To: Quinault Indian Nation

From: Natural Systems Design, Inc.

Date: April 22, 2020

Re: Critical Review of Proposed Chehalis River Basin Flood Damage Reduction Project SEPA DEIS
Hydrology Technical Memo 2: HYDROLOGY and CLIMATE CHANGE TECHNICAL ANALYSES REVIEW

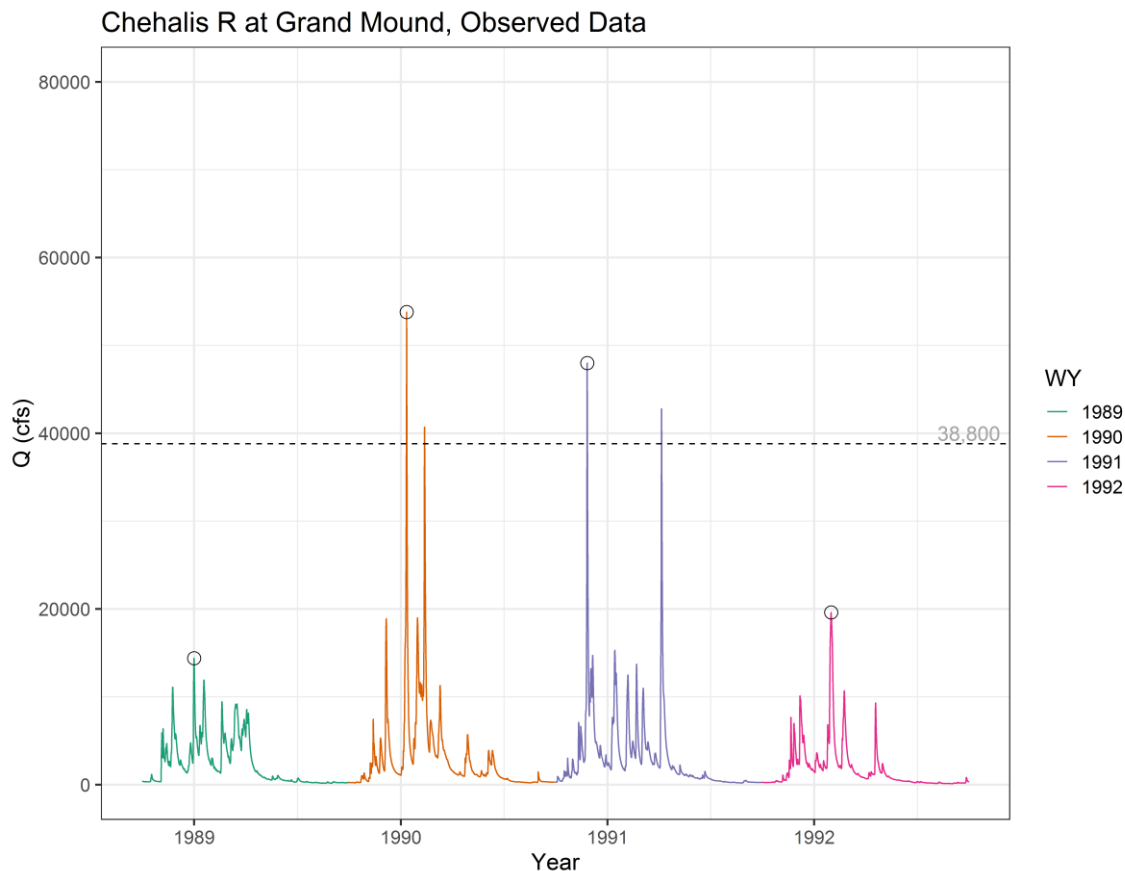
- 1. In the DEIS, the analysis of FRE operation under both current and future climate conditions is based on the recurrence interval determined by an Annual Flood Frequency Analysis only, rather than the frequency with which the relevant peak flow threshold of 38,800 cubic feet per second (cfs) at Grand Mound is exceeded.**

Streamflow observations at Grand Mound provide examples of water years in which there are multiple, independent peak flow events that exceed the 38,800 cfs flow threshold at Grand Mound. A portion of the historical record is shown in Figure 1, illustrating that during WY 1989 to 1992 there are 2 annual peaks (peaks

marked with open circles above dashed horizontal line in Figure 1) but a total of 4 independent peaks that exceed the 38,800 cfs threshold.

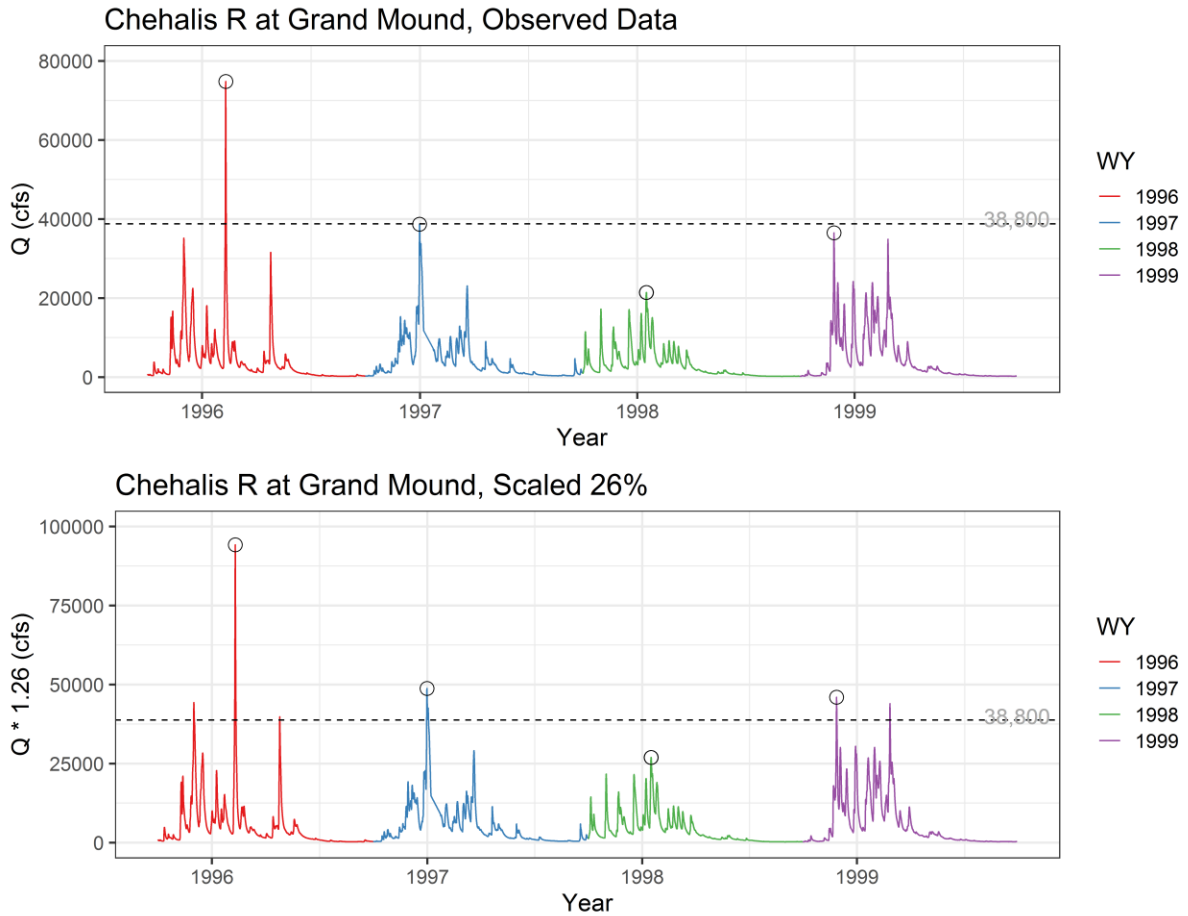
FRE facility would be operated once every 1.8 and 1.4 years, on average, under mid- and late-century climate scenarios. **Thus, the FRE facility will operate more frequently than stated in the DEIS.** The example below illustrates the need for this type of frequency analysis; under future conditions (i.e., estimated by scaling peak flows by 26%) both WY 1996 and WY 1999 experienced multiple, independent peak flows greater than 38,800 cfs (Figure 2).

Under historical conditions, there would have only been one flow that exceeded the FRE operation threshold of 38,800 cfs during this time period shown in Figure 2 (note that the peak flow in WY 1997 was 38,700 cfs and was 100 cfs under the threshold). However, when the flow record is scaled to account for projected future conditions, there are six events that exceed the threshold during this time period with WY 1996 and WY 1999 experiencing multiple events. The multiple exceedances of the FRE operation threshold during individual WYs have not been accounted for in many of the analyses used to assess impacts in the DEIS.

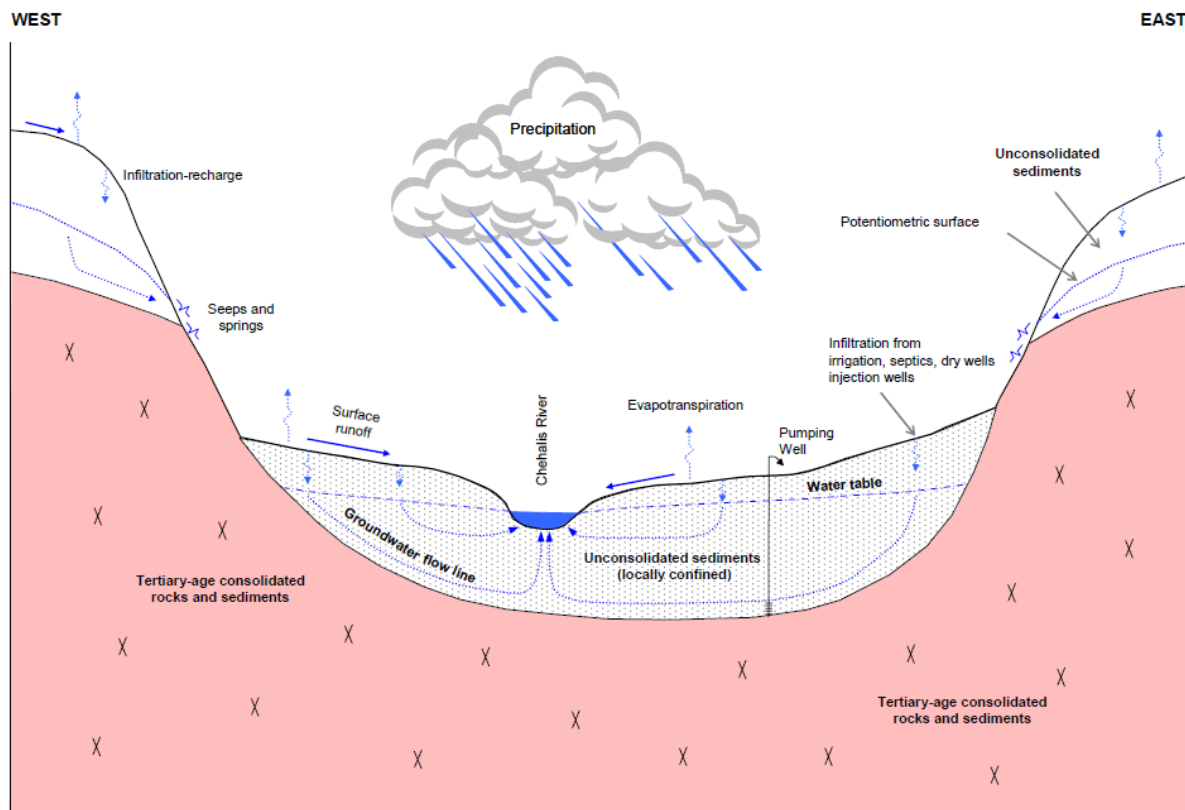
1) The DEIS does not sufficiently assess the linkages between impacts to groundwater and impacts to wetlands, floodplain water bodies, and baseflow downstream of the FRE facility. The DEIS focuses on the area affected by impacts to groundwater as the acres no longer inundated during a major or catastrophic flood with the implementation of the Proposed Project (i.e., 3,514-4,679 acres in Table N-13). However, as noted in the conceptual model of groundwater flow in the Centralia-Chehalis Lowland portion of the Chehalis basin (Figure 6 in Wilson et al., 2019 and in Pitz et al. 2005, and reproduced below as Figure 3), groundwater moves laterally in the subsurface and typically contributes water to streamflow in the Chehalis basin.

The DEIS fails to sufficiently assess impacts to wetlands, floodplains, and surface flows that are within the area of the floodplain that will continue to be inundated but down-gradient (i.e., receives groundwater flow from) of the area of floodplain that will no longer be inundated during a major or catastrophic flood. The wetlands discipline report (DEIS, Appendix O) notes that “the reduced area of inundation could also potentially affect groundwater levels and groundwater infiltration in the downstream floodplain on a periodic basis” but refers to the analysis within the water discipline report (DEIS, Appendix N) and the Potential Groundwater Level Effects Analysis (Wilson et al., 2019), both of which are insufficient for the reasons described below.

Figure 4. Projected reductions in extreme low flows, represented by the 7Q10 (see text) at the Chehalis River at Grand Mound from a previous modeling effort (Hamlet et al., 2013). Data accessed at <http://warm.atmos.washington.edu/2860/products/sites/?site=6004>.

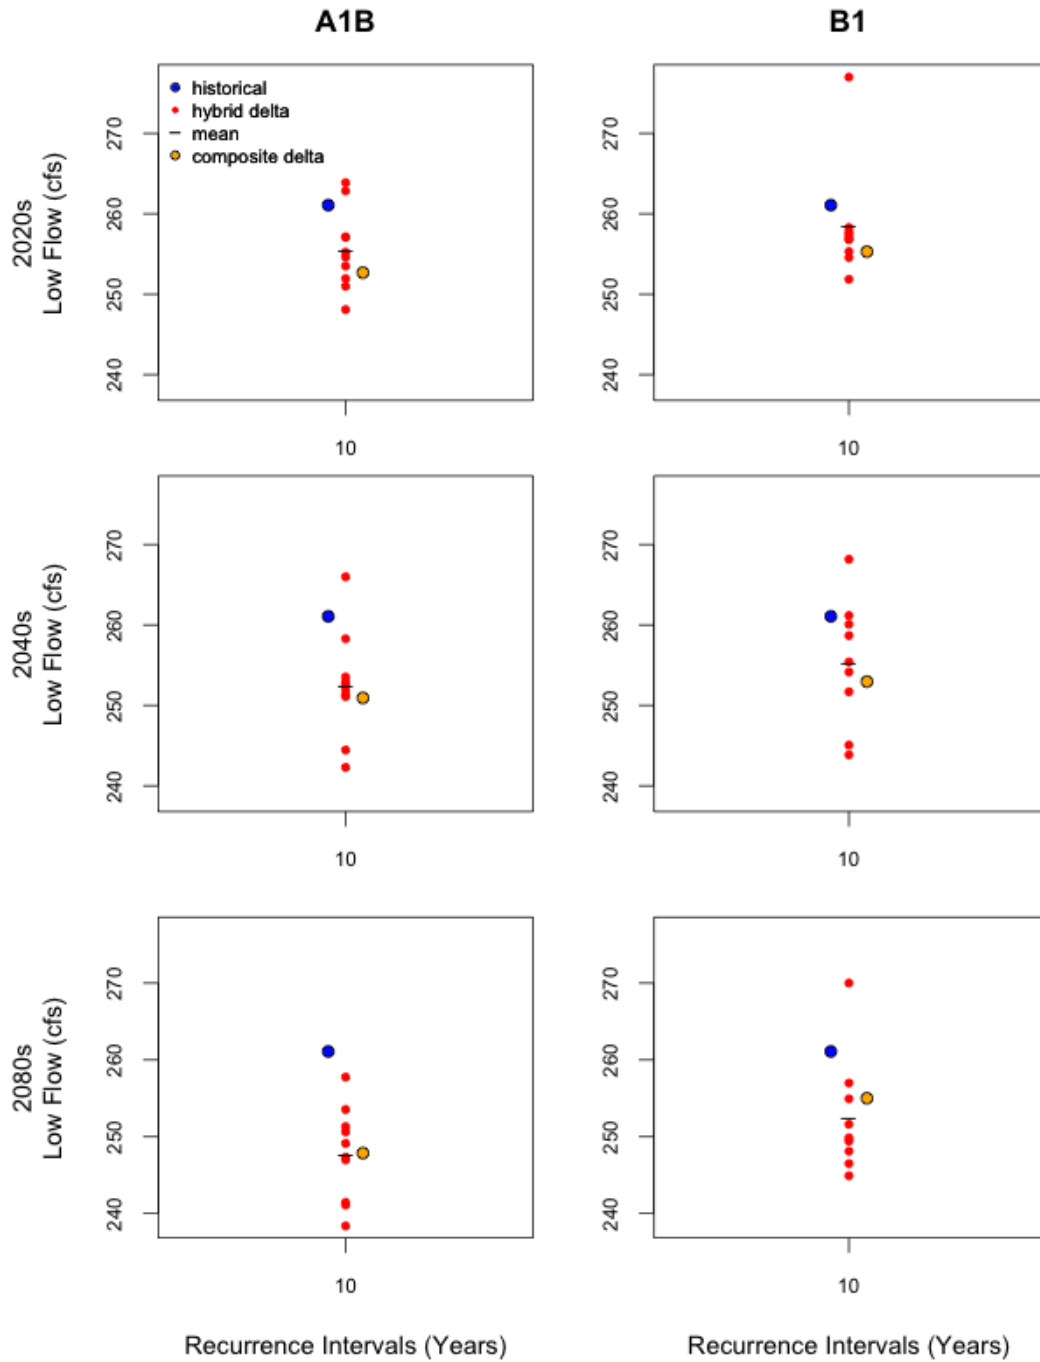
The potential for impacts from the FRE facility to amplify the climate change impacts to low flows and stream temperature are not considered in the DEIS assessment of groundwater or wetlands. Projections for future streamflow during the dry summer season indicate that low flows will further decrease into the future. Climate change modeling for the DEIS estimates a 11% and 16% in average summer flows by mid- and late-century, respectively (Table 2 of Hill and Karpach, 2019). In addition, previous hydrologic modeling of climate change impacts for the Chehalis River at Grand Mound projected that the lowest 7-day average streamflow with a recurrence interval of 10-years (i.e., the 7Q10, which is a commonly used low flow metric) is projected to decrease by late century (Figure 4; Hamlet et al., 2013). The previous modeling utilized the ensemble approach, with nine GCMs (red dots in Figure 4) and two emissions scenarios (A1B and B1, shown as columns in Figure 4) from the IPCC Fourth Assessment (AR4). The reduction in extreme low flows by end of century for the A1B scenario (i.e., a medium emissions scenario) in extreme low flows is 5% on average (black horizontal dash in Figure 4) and ranges up to 9% in the ensemble of GCMs.

Although these reductions in low flow are projected to occur independently from the Proposed Project, several of the impacts quantified in the DEIS including loss of wetlands and reduction in groundwater recharge will amplify the projected lower low flows in the future, resulting in more severe impacts to aquatic habitat. By not considering projections for low flows along with impacts to groundwater recharge and wetland the late-century impacts to aquatic habitat and treaty resources cannot be quantified in a meaningful way.
